2017MY
Niro (DE HEV)

PS553

HEV WARNING LIGHT AND DTC P1B25/P1B77

Hi-Voltage Battery Fuse

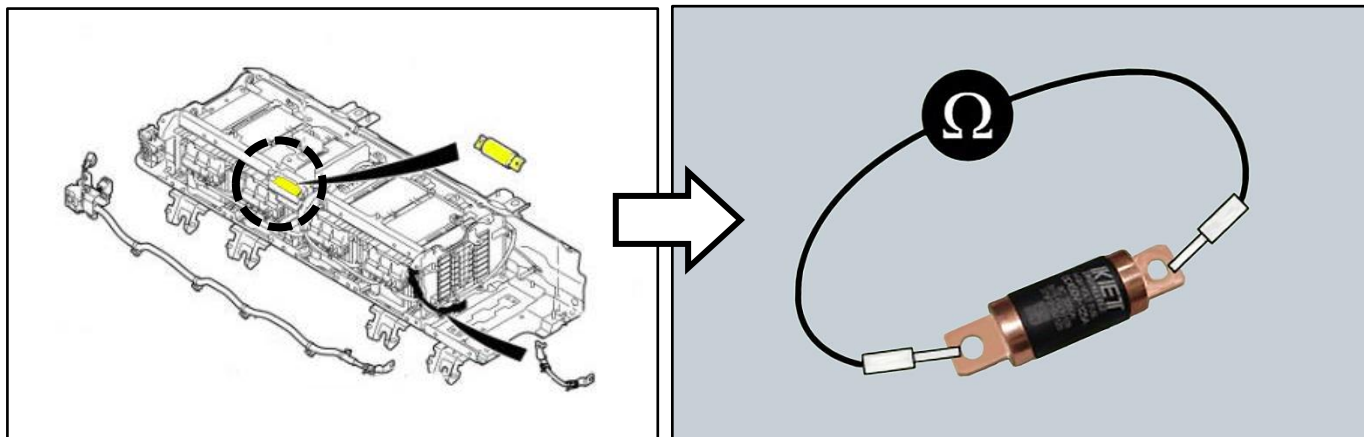
When addressing a concern related to the Niro HV warning light ON, and KDS detects a primary DTC P1B25 (HV Path Fault) and secondary DTC P1B77 (HV Pre-Charge Fault), then the 125 Amp High Voltage Battery Fuse should be inspected for an intermittent and/or an open condition.

Measure the resistance while tapping on the fuse (less than $<1\Omega$ resistance).

Specification: 1Ω or less (68°F)

If the measured resistance is not within specification, or the P1B25 DTC is intermittent, replace the 125 Amp main HV battery fuse with the newer 170 Amp main HV battery fuse.
(Refer to EPC 37-371)
